Jemena submission to specification of service points, zones and pipeline segments for capacity trading platform and auction

AEMO Consultation Paper dated 4 July

27 July 2018

Figure 2 - Longford Zone

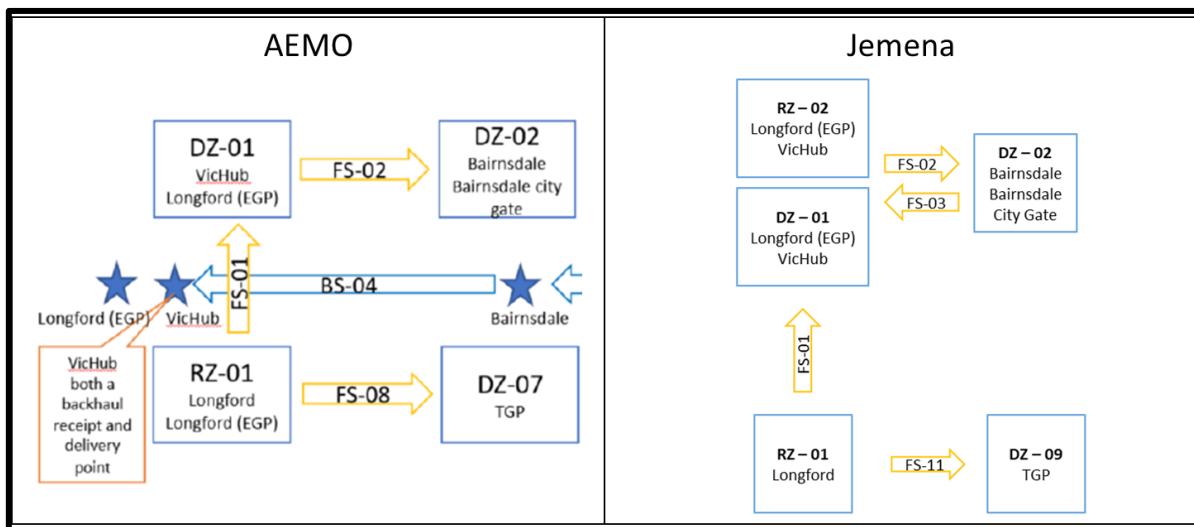
The proposed alteration by Jemena includes a new Receipt Zone between FS-01 and FS-02 to account for the ability for gas to be received from Park services, as well as from VicHub. The Jemena proposed RZ-01 also identifies that Park Services do not originate from upstream of FS-01, but rather downstream of this pipeline section. This concept is consistent to the service point method applied on other pipeline assets with similar park services to those offered by Jemena and with AEMO's own view of service points for park services (page 22 of the consultation paper).

To proceed without either of these modifications can lead to unnecessary scheduled quantities across FS-01, as well as less MDQ made available to FS-02. Both of these outcomes could lead to the undermining of the Day Ahead Auction concept, with either services won through auction routinely being de-scheduled, or asset capacity misaligned with Eastern Gas Pipeline uncontracted capacity disclosures.

Figure 3 - Orbst Zones

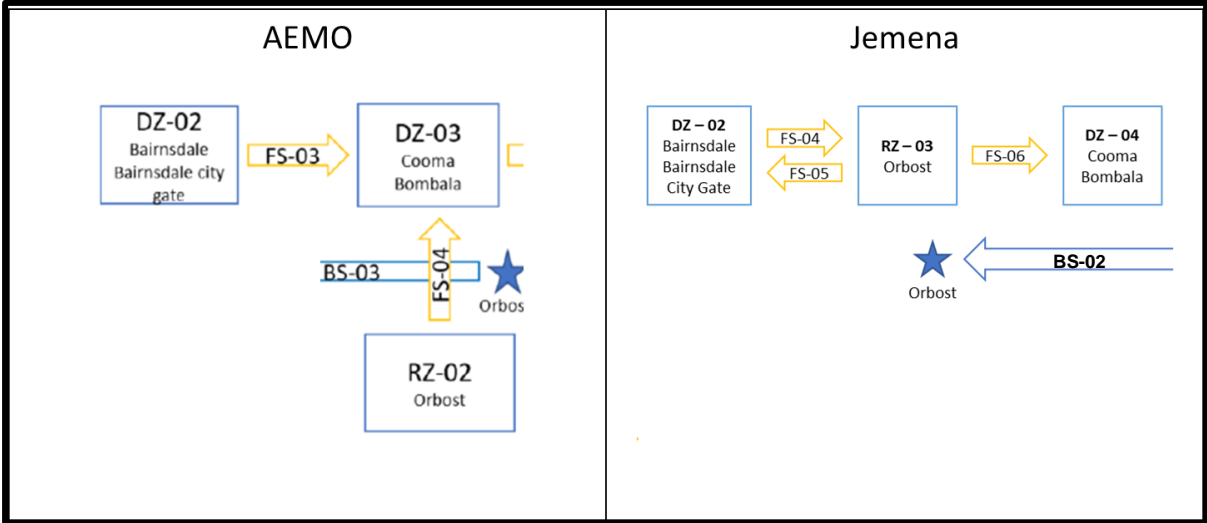
This proposed alteration accounts for the fact that there is no Pipeline Segment between Orbst and the Eastern Gas Pipeline mainline, nor does Orbst feed into the Delivery Zone containing Cooma and Bombala.

Simply removing AEMO's FS-04 however isn't an accurate representation of the asset either as this would place the Receipt Zone containing Orbst adjacent to the Cooma Bombala Delivery Zone. This is the principle underpinning Jemena's proposed FS-06.

Figure 4 - Orbst Connection

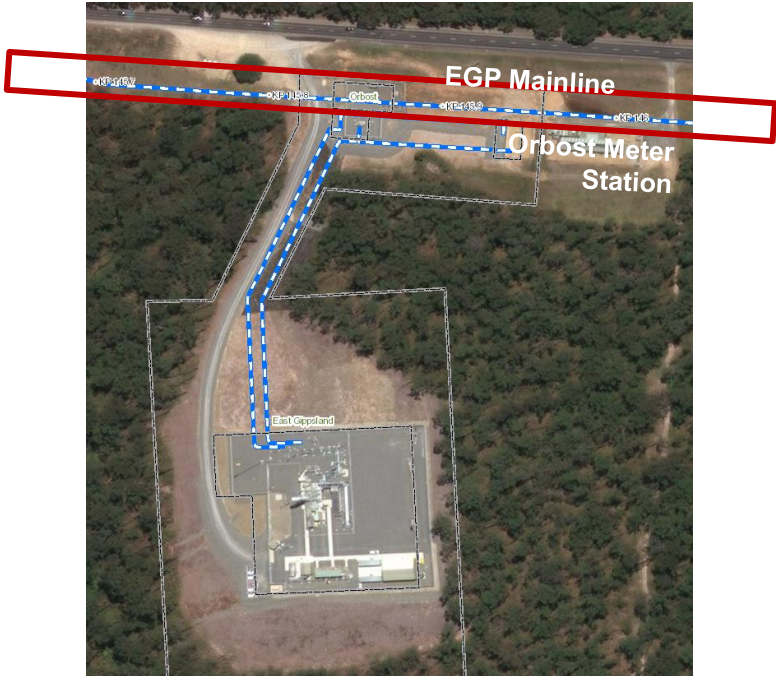
Orbst Meter Station ties into the upstream side of the East Gippsland Compressor, and as indicated in Figure 4 below, is in fact closer in proximity to the EGP mainline than the compression facility itself. Including a Pipeline Segment here would be a misrepresentation of the physical infrastructure, and if it was included it would be assigned the exact same Capacity, MDQ and Scheduled data as the Orbst Receipt Point.

Figure 5 - Eastern Gas Pipeline - South

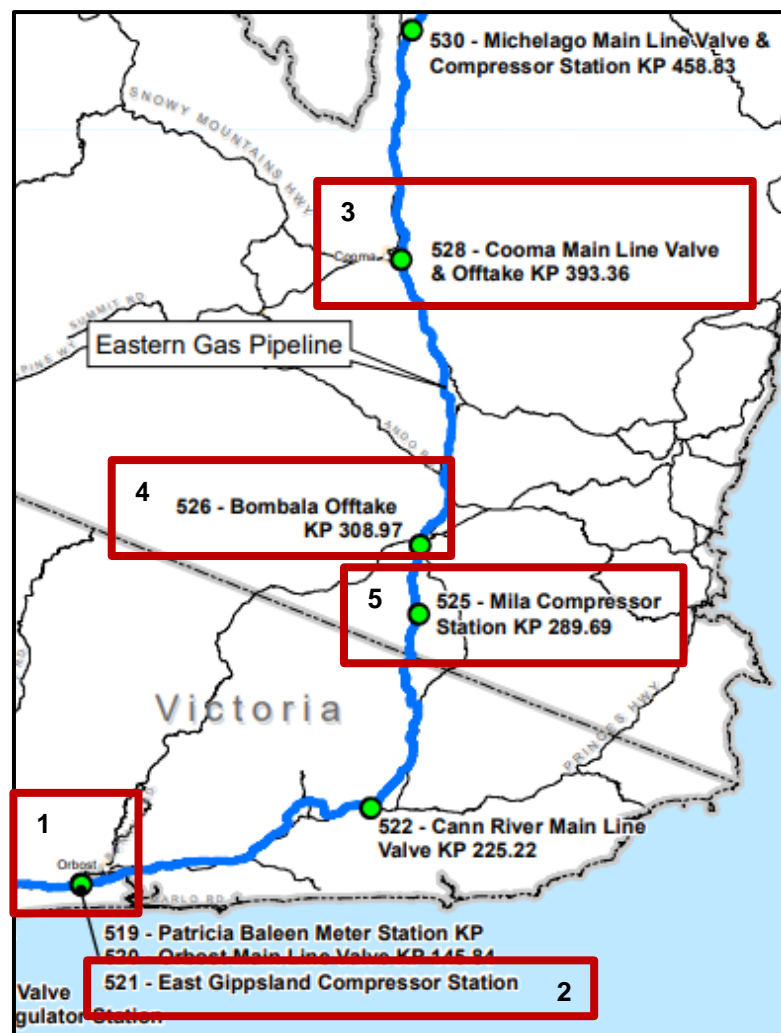
The map in Figure 6 below shows that gas from Orbost (Highlight 1) is received onto the EGP mainline upstream of the East Gippsland Compressor Station (Highlight 2), and that Cooma (Highlight 3) and Bombala (Highlight 4) are Delivered off of the EGP mainline downstream of the Mila Compressor Station (Highlight 5). This shows that there is a definitive Pipeline Segment between Orbost and both Cooma and Bombala.

Jemena’s proposed FS-06 is not solely a stretch of pipeline, but a stretch of pipeline including two compressor stations. Each of the compressors and the pipeline itself directly impact EGP capacity. To ignore these capacity constraining elements by suggesting that Orbost is received adjacent to Cooma and Bombala could lead to the undermining of the Day Ahead Auction concept, with services won through auction being routinely de-scheduled

Figure 6 - Horsley Park Area

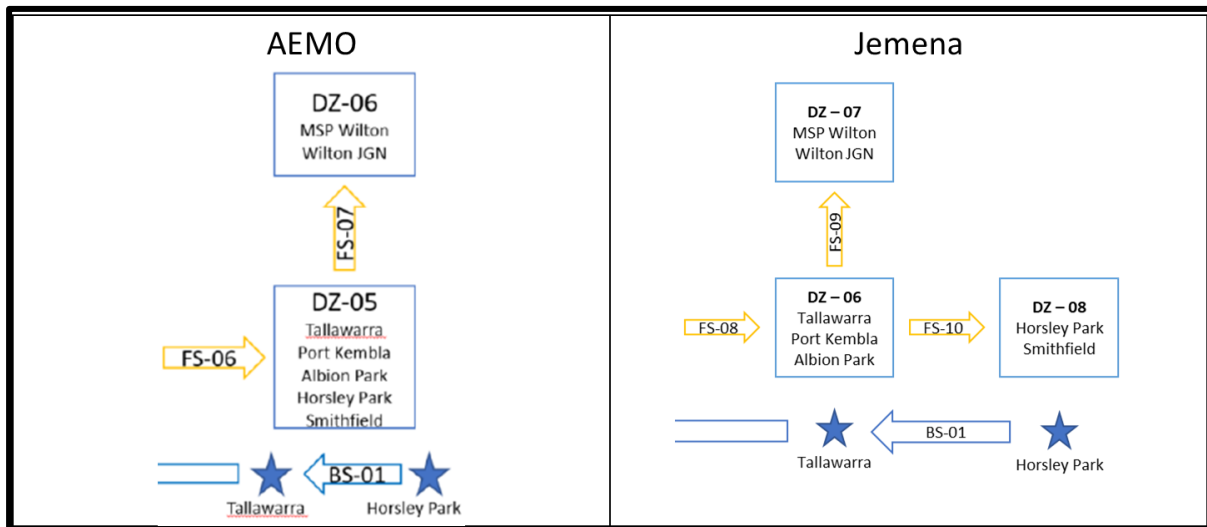
This proposed alteration removes Horsley Park and Smithfield from AEMO DZ-05, creating the Jemena proposed DZ-08 and FS-10. This configuration accounts for the capacity constraining element which exists at Horsley Park, being the Horsley Park Water Bath Heaters. Both Horsley Park deliveries and gas flowing onto the Smithfield Lateral pass through these Water Bath Heaters, resulting in a combined capacity constraint which Jemena proposes be addressed through the inclusion of FS-10. The capacity constraint associated with the Smithfield Lateral itself can be included in the Smithfield Delivery Point Capacity.

Failing to account for this capacity constraint between Jemena proposed DZ-06 and DZ-08 could result in Contracted But Unnominated Capacity being purchased at auction originating at Tallawarra, Port Kembla, or Albion Park, with the intent to use this at either Horsley Park or Smithfield, despite the fact that both of these Delivery points are constrained by the Horsley Park Water Bath Heaters. This scenario, which Jemena's data identifies as being a frequent occurrence if unaddressed (due to the high utilisation of Horsley Park) could lead to the undermining of the Day Ahead Auction concept, with services won through auction being routinely de-scheduled.

Figure 7 - Eastern Gas Pipeline Bidirectional Zone

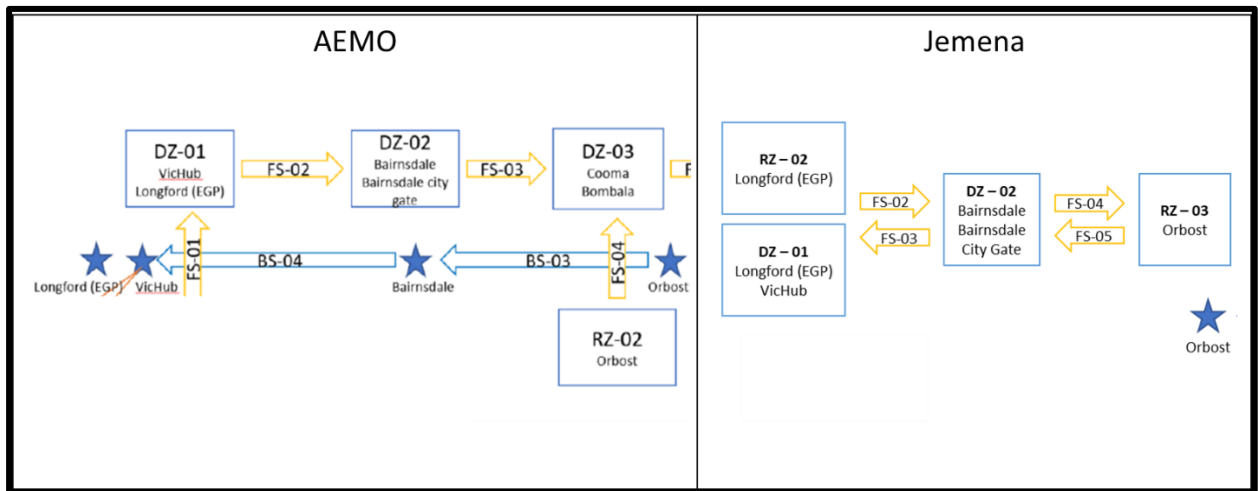
While AEMO has proposed backhaul segments from Orbost, via Bairnsdale, and through to VicHub and Longford, it is physically possible to forward haul gas from Orbost to Bairnsdale, Longford and VicHub. With physical capability and a Firm Forward Haul service on offer being the two requirements for Bidirectionality on a pipeline, Jemena identifies both the physical capability and the intent to have a Firm Forward Haul service on offer for Orbost to Longford before the 1 March 2019 commencement date of the Day Ahead Auction. This is to coincide with the commencement of flow from the Orbost Plant.

As such, Jemena proposes that AEMO proposed BS-04 and BS-03, as well as Backhaul Delivery and Receipt locations for Bairnsdale, Longford (EGP) and VicHub be removed and replaced with Jemena proposed FS-03 and FS-05.

Figure 9 - Gladstone Area

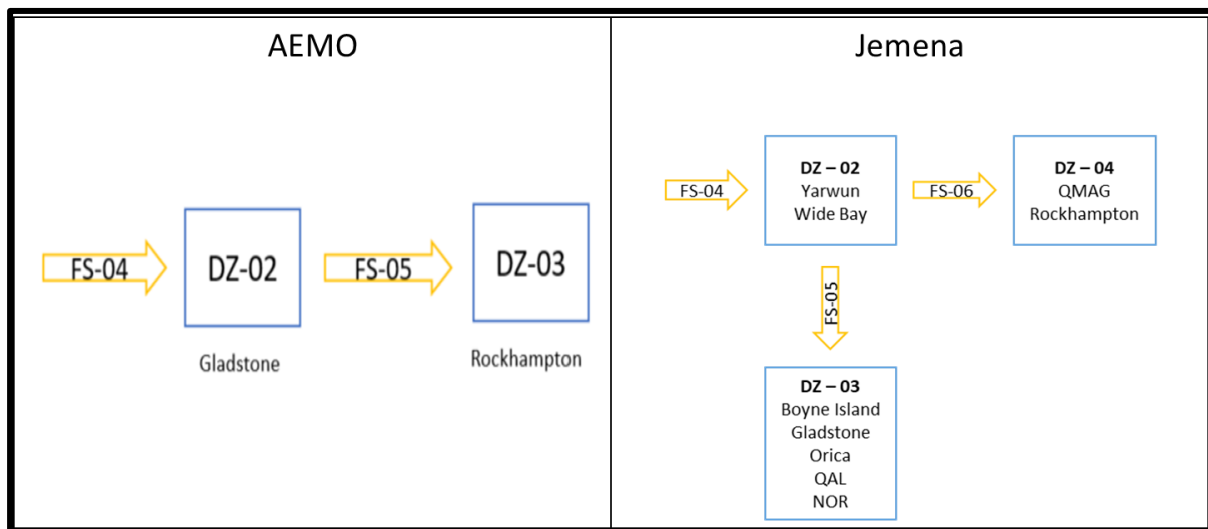
While AEMO proposes DZ-02 contains all Delivery Points within the Gladstone region, Jemena proposes that these be separated per Jemena's proposed DZ-02 and DZ-03 indicated above. This is due to the existence of a Regulation Station existing between these groups of Delivery Points, which behaves as a capacity constraining element.

Failing to account for this capacity constraint between Jemena proposed DZ-02 and DZ-03 could result in Contracted But Unnominated Capacity being purchased at auction originating at Yarwun with the intent to use this at either Boyne, Gladstone, Orica, QAL or NOR, despite the fact that these Delivery points are constrained by the Regulation Station. This scenario has the potential to undermine of the Day Ahead Auction concept, with services won through auction being routinely de-scheduled.

Figure 11 – Talinga Area Zones

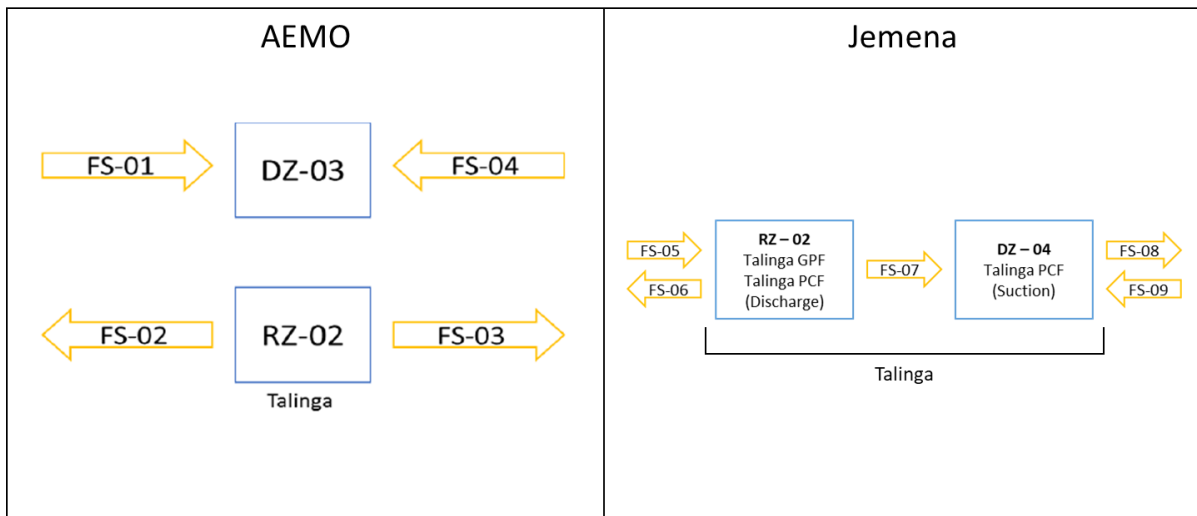
AEMO's proposed DZ-03 (Talinga Compression & DDP to APLNG) and RZ-02 (Talinga Compression & APLNG to DDP) are depicted as adjacent Zones with bidirectional pipelines flowing east and west of these Zones. This is inaccurate both from a pipeline segment and zone content point of view.

Figure 12 - Talinga Area

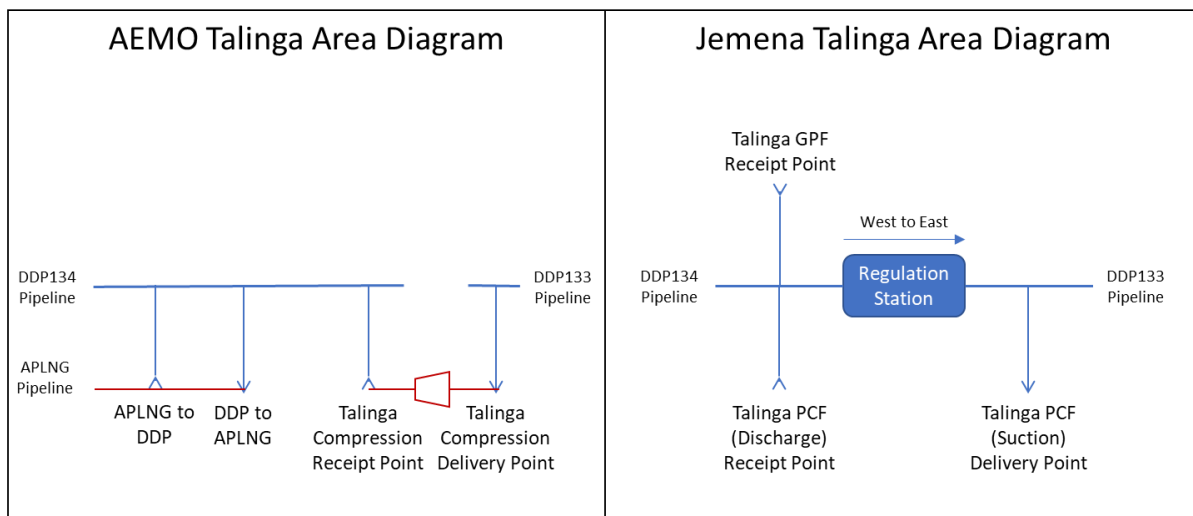
Firstly, regarding physical asset configuration, please consider the following correction to AEMO's current perspective of the configuration of Talinga area.

AEMO and Jemena have had a number of discussions regarding the complexity of the DDP network. The configuration indicated in Figure 12 is an attempt to strike a balance between providing a workable representation of the operational configuration, without adding unnecessary complexity and detail. Hence Jemena’s proposal is for three connection points. These differences will be reflected in changes which Jemena intends on introducing to the GasBB prior 1 March 2019.

Figure 13 - Wallumbilla Area and PPL90

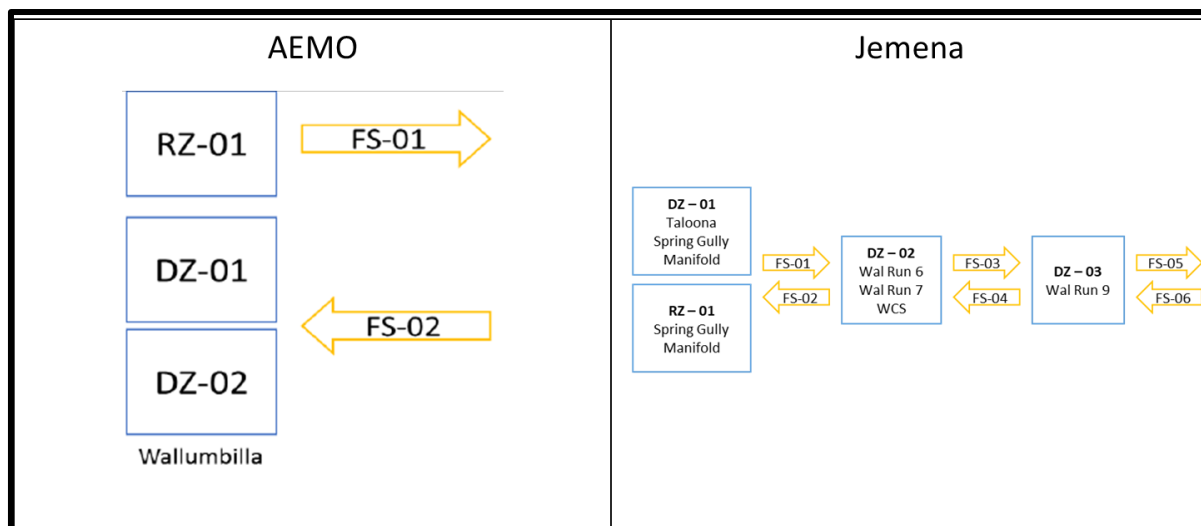
Starting from the left, the locations which AEMO have identified in SGP RZ-01 and DZ-02 at the northern extremity of the SGP have been modified since originally set up in GasBB. These are now referred to as the Spring Gully Manifold, upstream of which there is a network of receipt and delivery points owned and

operated by a third party. As such, these points have been renamed to better reflect the current design of the asset.

In joining the SGP to the DDP, Receipt Zone 1 on the SGP and Delivery Zone 2 no longer exist, however two new pipeline segments, FS-03 and FS-04 are proposed to reflect the capacity constraining element which exists between the Delivery Points within Jemena's proposed DZ-02 and Jemena's proposed DZ-03.

From Jemena proposed DZ-03, Jemena proposed FS-05 and FS-06 combine the capacity constraining elements of both the DDP134 pipeline segment, and the facility known as SGW, which is in and of itself a capacity constraining element. Jemena proposed FS-05 and FS-06 ultimately flow onto the Talinga area, completing the physical interconnectivity of the asset.

Jemena has proposed that DZ-02 and DZ-03 are separated by FS-03 and FS-04 to address the possibility of capacity being won on the Day Ahead Auction which has originated at Wallumbilla Run 9, with the intent to use this capacity at either Wallumbilla Run 6, Wallumbilla Run 7 or WCS. This scenario has the potential to undermine the Day Ahead Auction concept, with services won through auction being routinely de-scheduled.
